FIRST PROJECT

Doc.:
PT/8147

Subject: FIRST / PLANCK POWER EMC Working Group Mtg

Subject: ESA Response to JPL Comments on EMC portions of FIRST Planck IID-A

Working in IID-A as released in ITT.

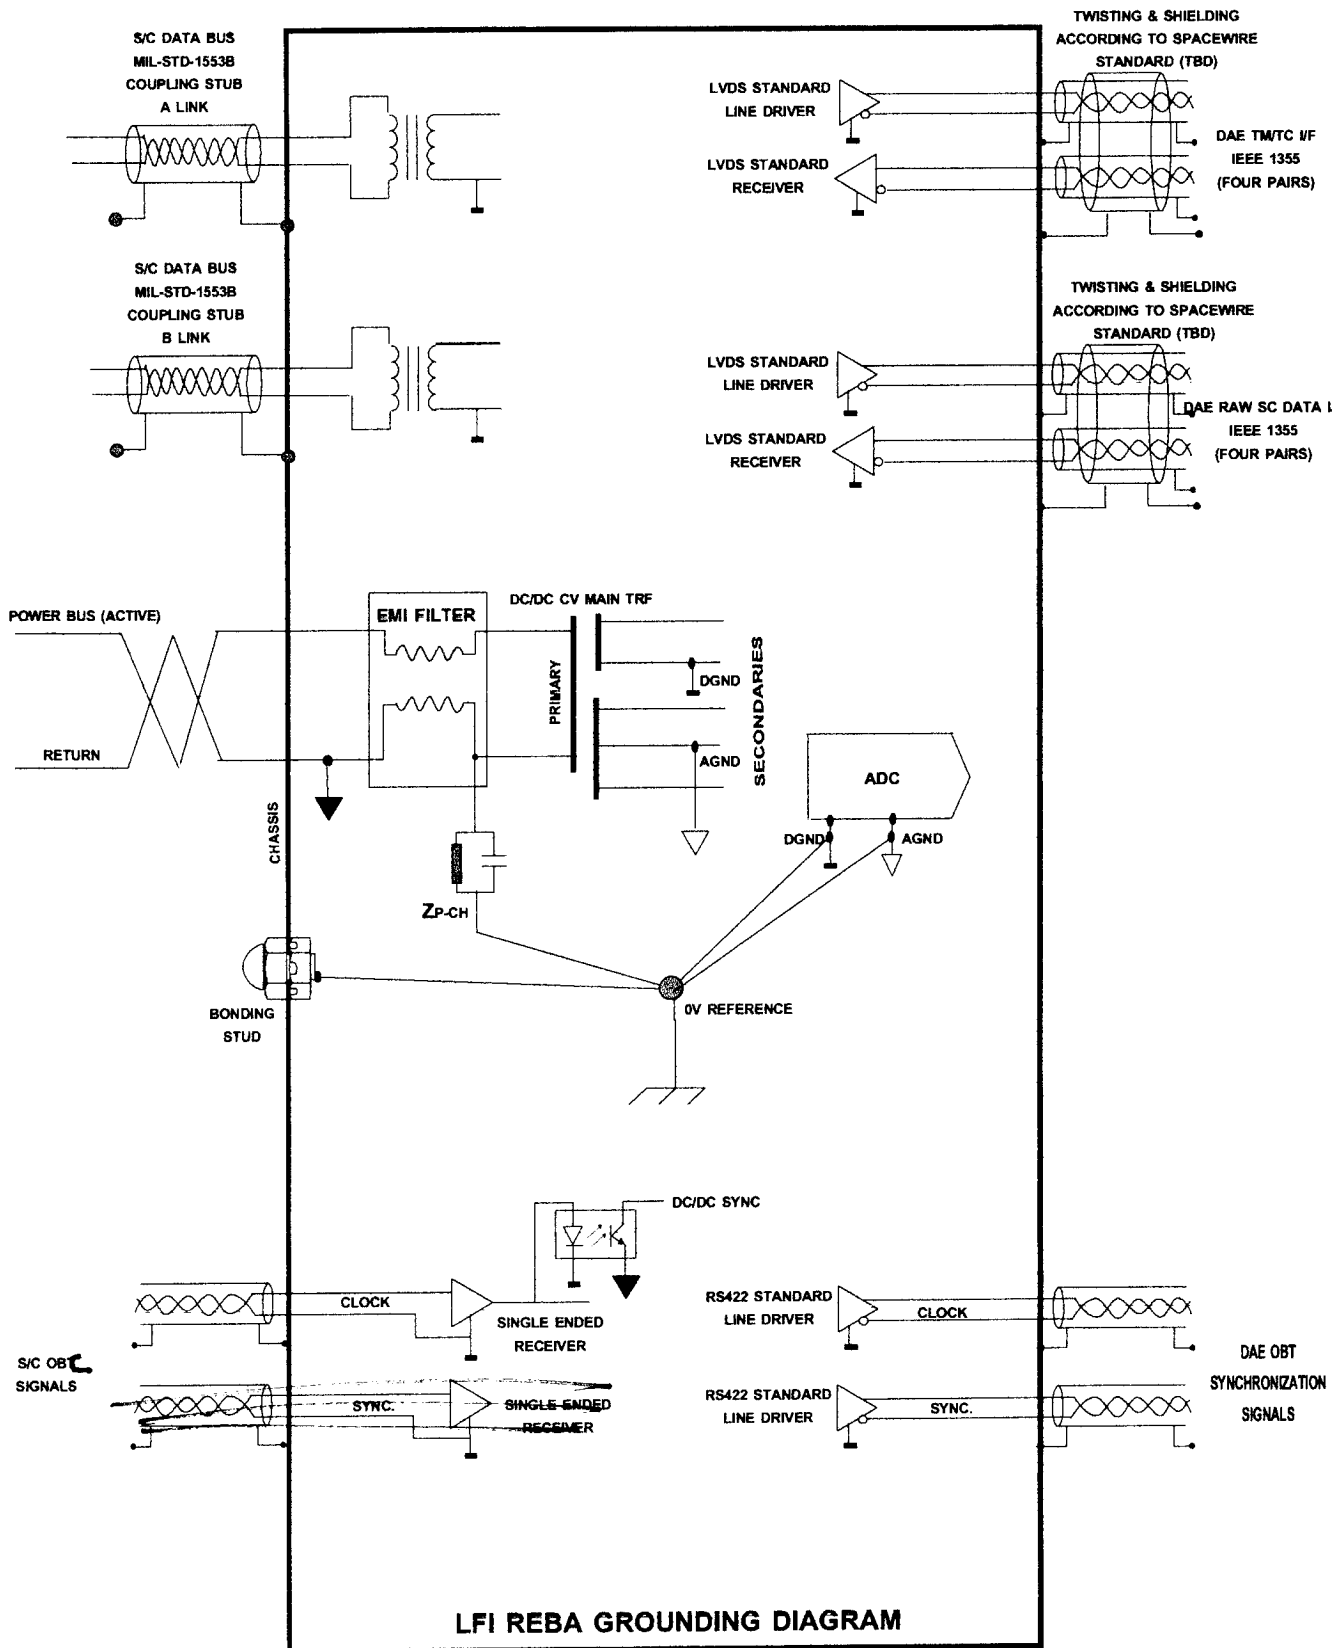
111111 proposed to be deleted. in
next issue of IID-A.

5.14.1.2 Signal Isolation

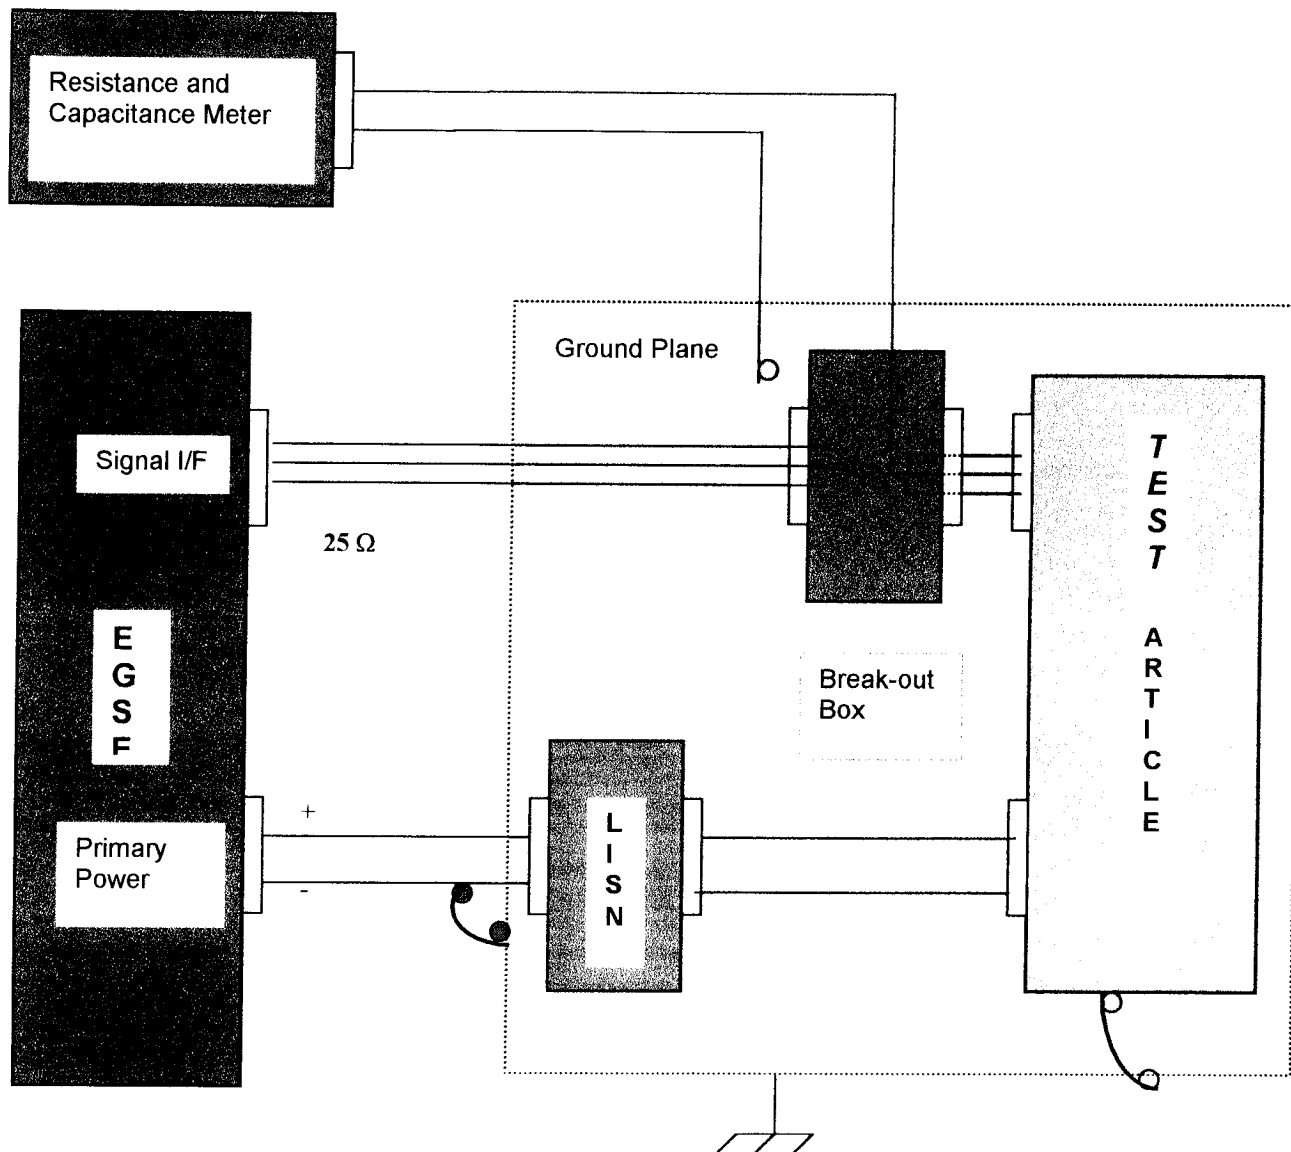
Suggest that all the "shall" wording be changed to "should". This is not readily verifiable by test.

The intended test set up and the test procedure is shown here below.

This measurement is matter of few minutes and can be easily performed. Also, this requirement is meant to control common mode by designing appropriately the signal interfaces. If the experiments manufacturer has information on the common mode isolation of the amplifiers used, than this requirement may be verified by analysis. Slowly varying signals will certainly not contribute to common mode but they can be sensitive to it especially is extreme measurements are involved.

The designated ungrounded signal lines shall be tied together electrically. The impedance between the now common lines and the Test Article chassis shall be measured by applying a low fixed level AC voltage in the specified frequency range to the interface under test and adjusting a serial resistor to 50% voltage drop. The final value of the resistor is equal to the absolute value of the common mode isolation.

9.5.6.9 Line Impedance Stabilisation Network (LISN)

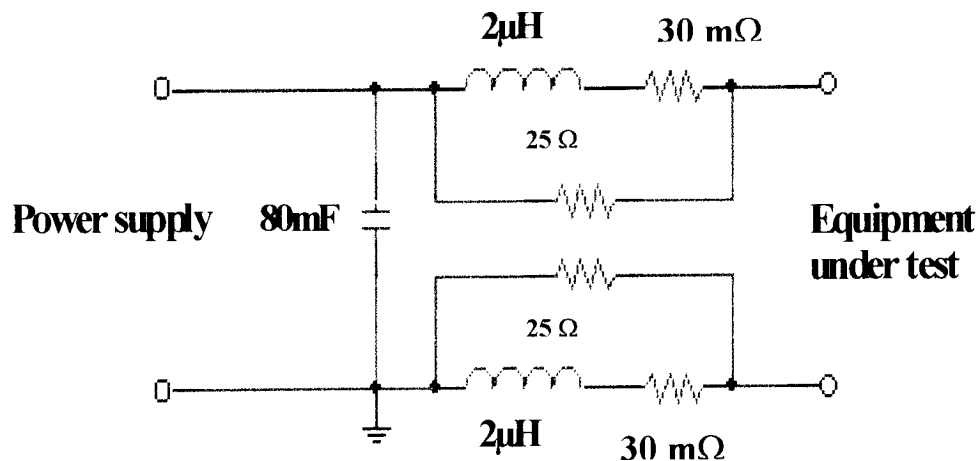
Figures 4.1 and 4.2 are missing or not properly referenced.

You are right. We provide the LISN used to generate the requirements here below:
